AMENDMENT C CHANGES. SHOWN CLOUDED.

VIEW FROM FISHERMANS BEACH UPDATED WITH NE PROPOSAL.  
DRAWING REGISTER UPDATED.

41 & 43 BEACH ROAD COLLAROY  
LO1 1 DP300846 AND LOT 2 SEC 7 DP7391

COVER + PHOTOMONTAGES

**Notes:**

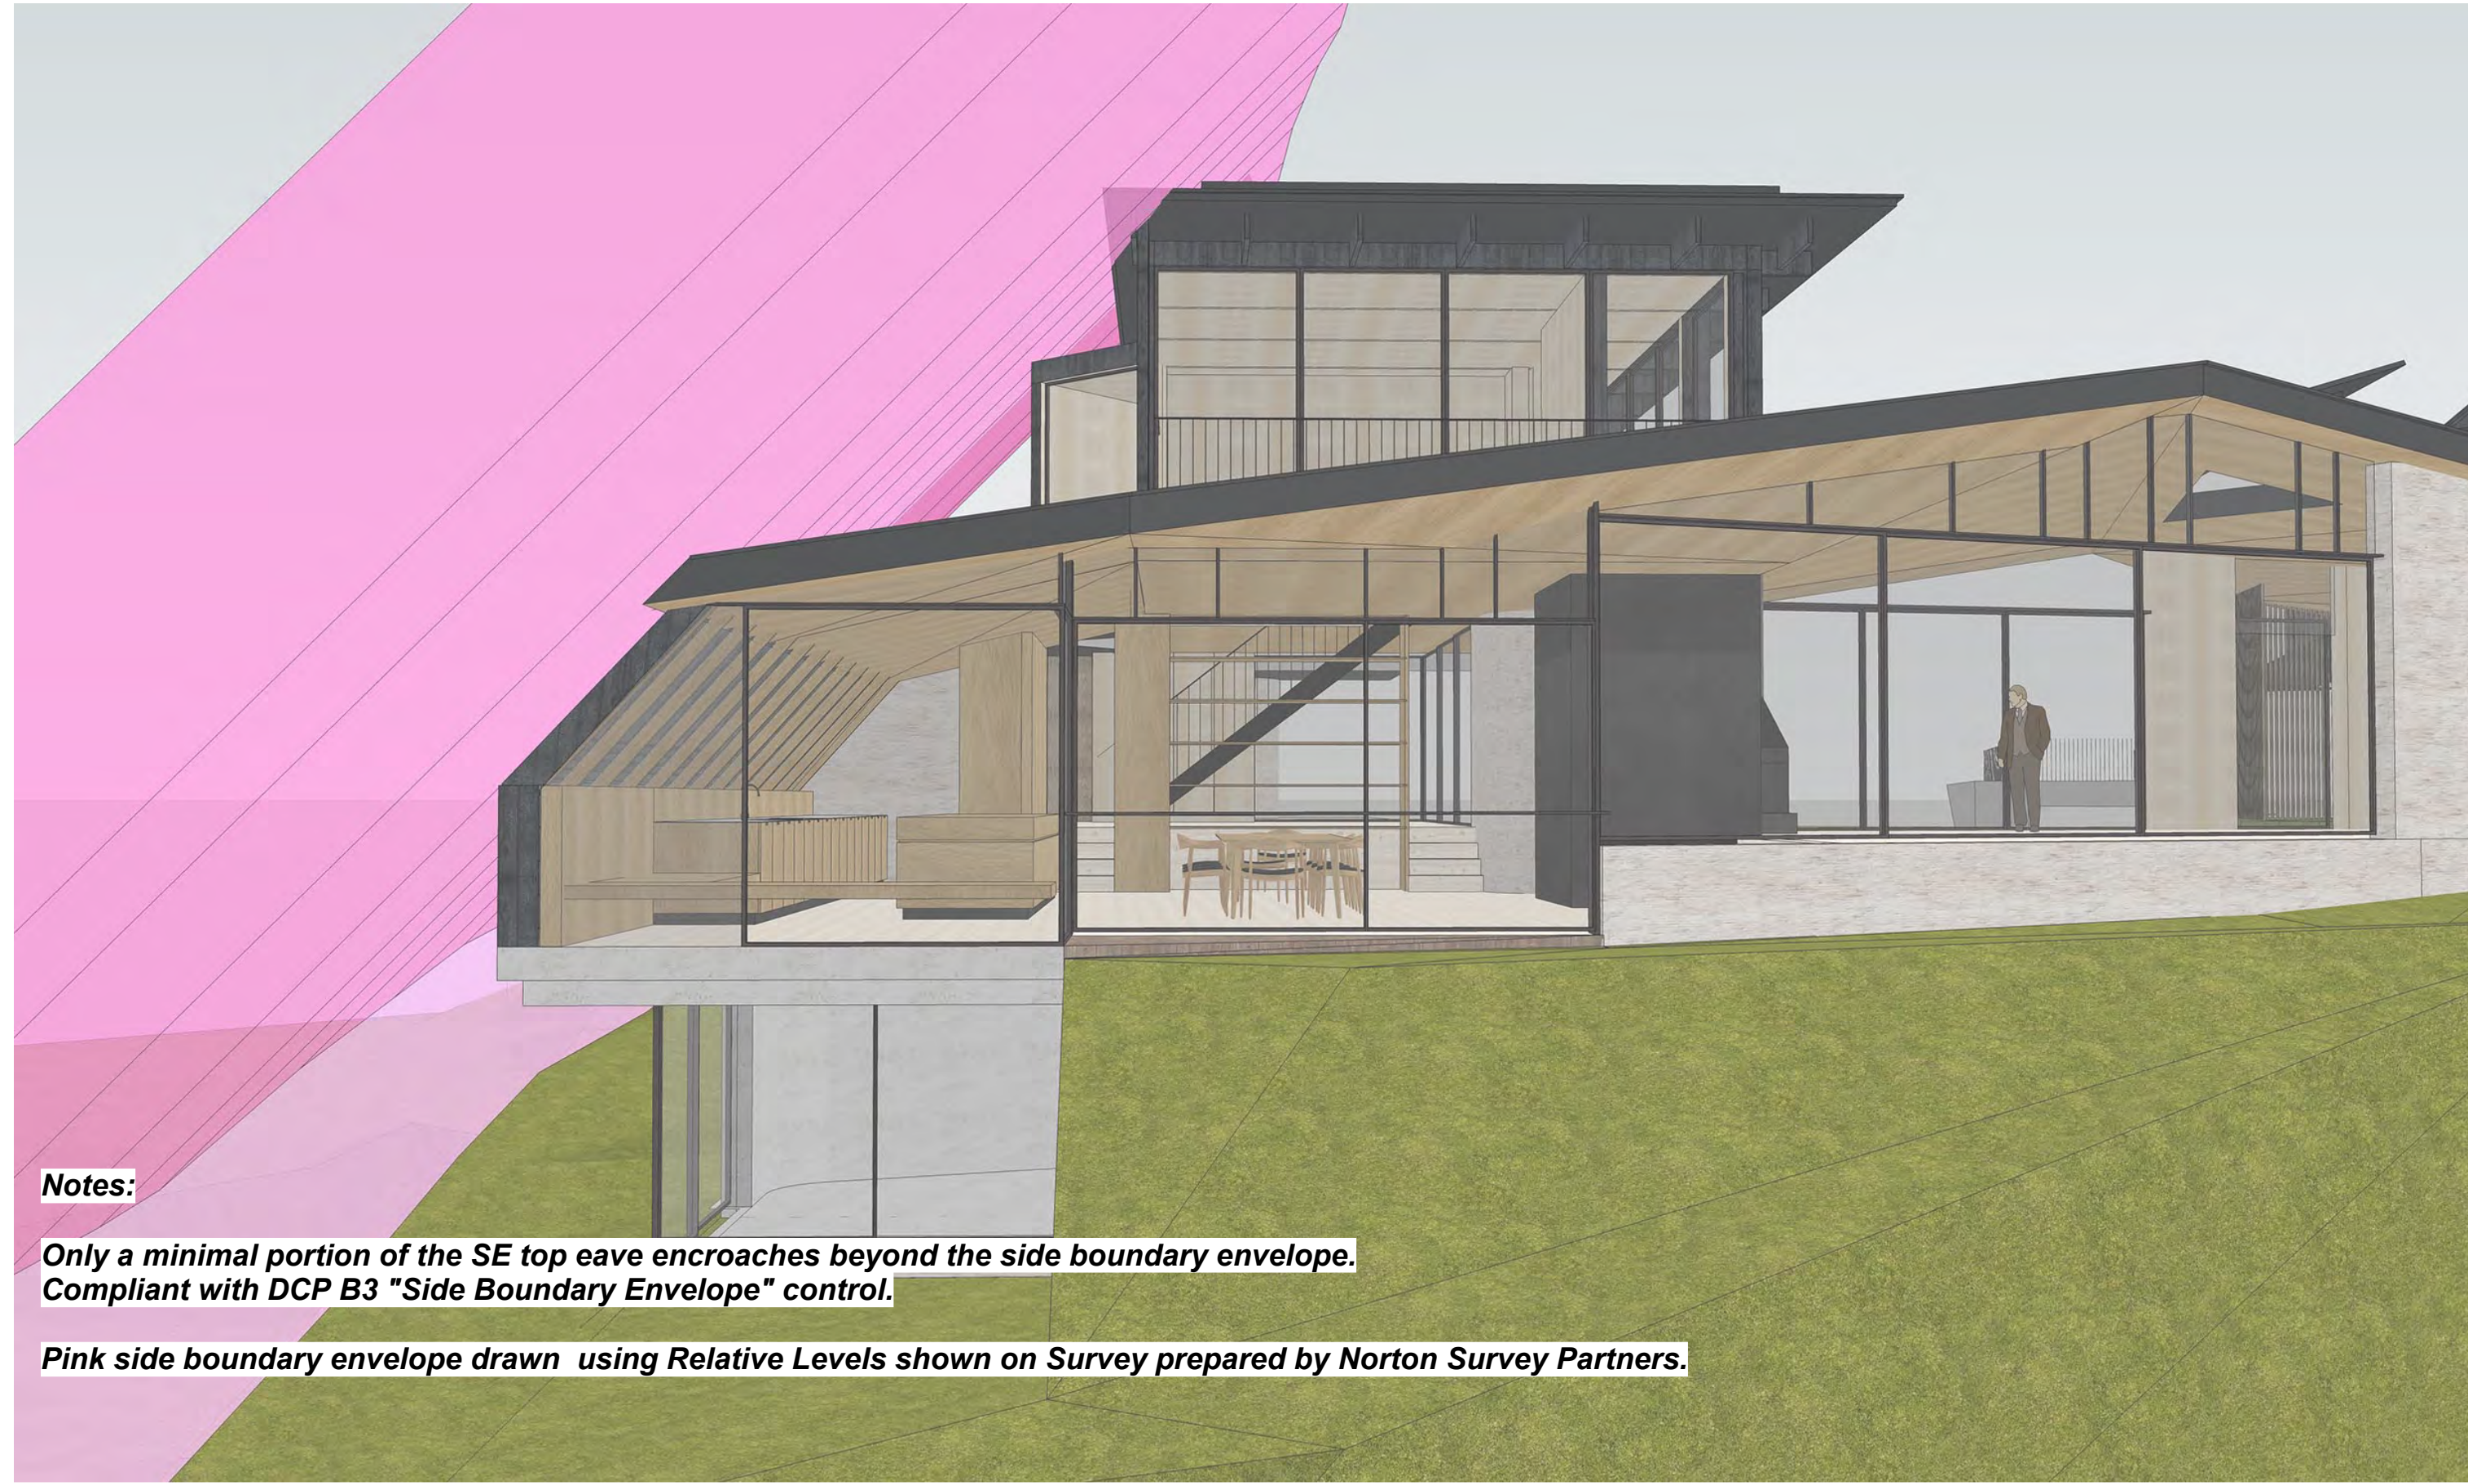
**Only a minimal portion of the SE top eave encroaches beyond the side boundary envelope. Compliant with DCP B3 "Side Boundary Envelope" control.**

3D image of Amendment "D" proposal. Prepared by VK.  
Assessed against DCP B3 "Side Boundary Envelope" control.

PHOTO EDITED BY VIRGINIA KERRIDGE ARCHITECT.  
OUTLINE OF PREVIOUS PROPOSED DEVELOPMENT SHOWN AS A YELLOW LINE - AMENDMENT C  
OUTLINE OF CURRENT PROPOSED DEVELOPMENT SHOWN AS AN ORANGE LINE - AMENDMENT D

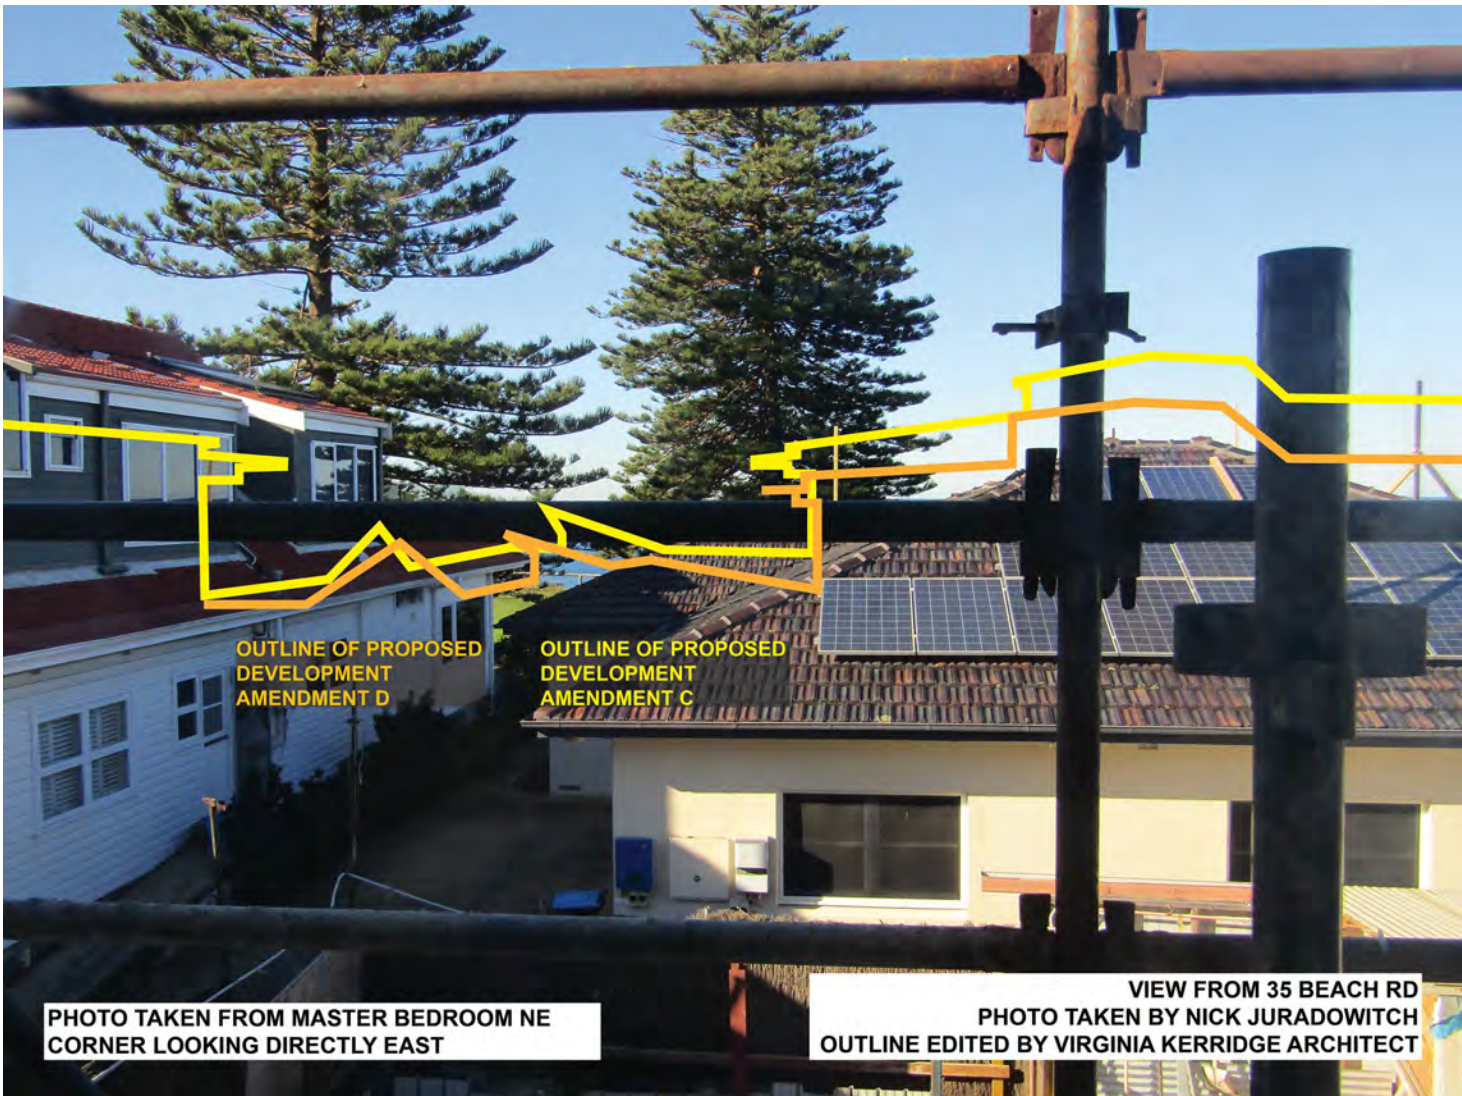
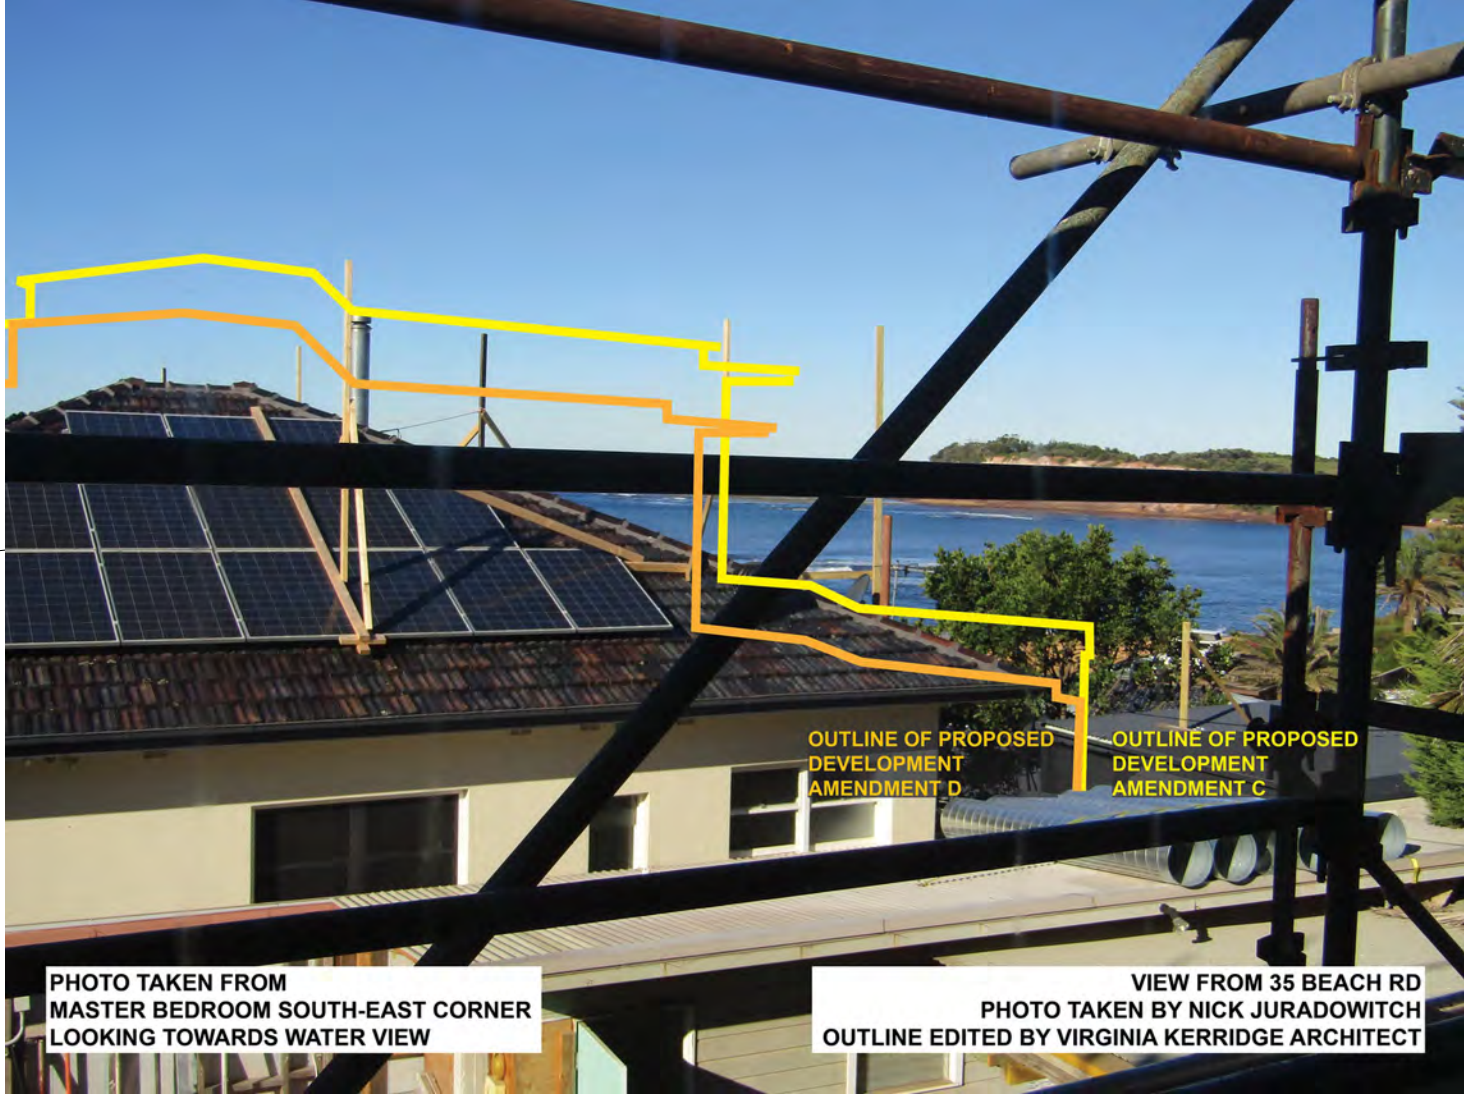
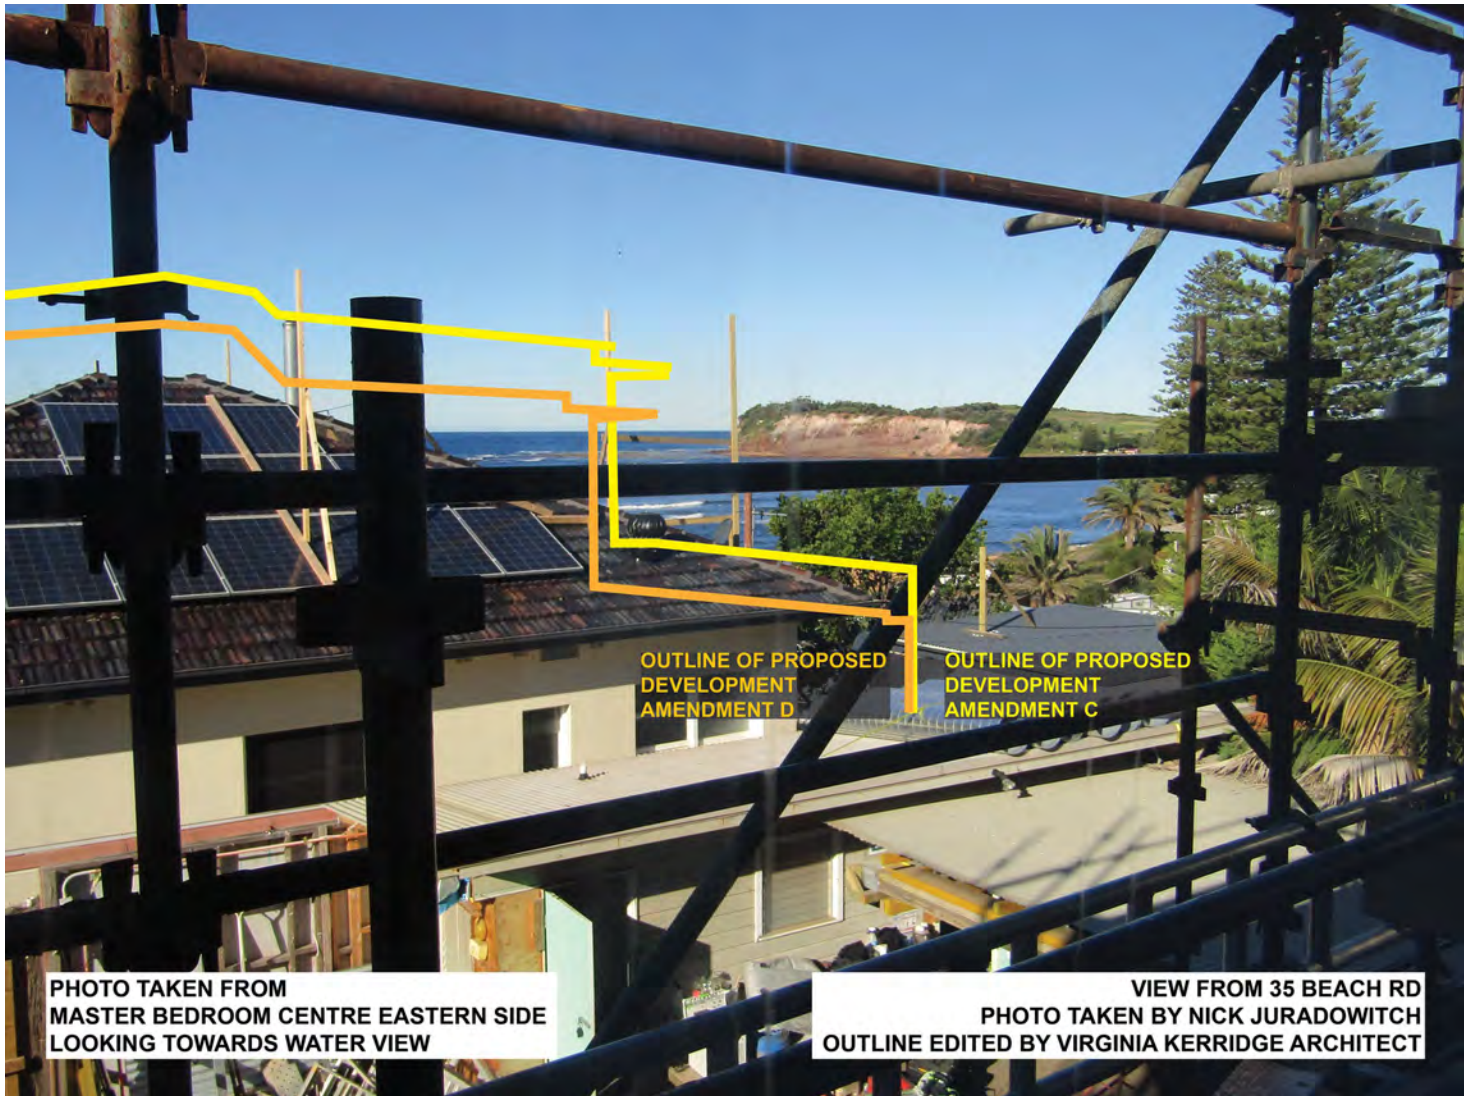
PHOTO EDITED BY VIRGINIA KERRIDGE ARCHITECT.  
OUTLINE OF PREVIOUS PROPOSED DEVELOPMENT SHOWN AS A YELLOW LINE - AMENDMENT C  
OUTLINE OF CURRENT PROPOSED DEVELOPMENT SHOWN AS AN ORANGE LINE - AMENDMENT D

PHOTO EDITED BY VIRGINIA KERRIDGE ARCHITECT.  
OUTLINE OF PREVIOUS PROPOSED DEVELOPMENT SHOWN AS A YELLOW LINE - AMENDMENT C  
OUTLINE OF CURRENT PROPOSED DEVELOPMENT SHOWN AS AN ORANGE LINE - AMENDMENT D
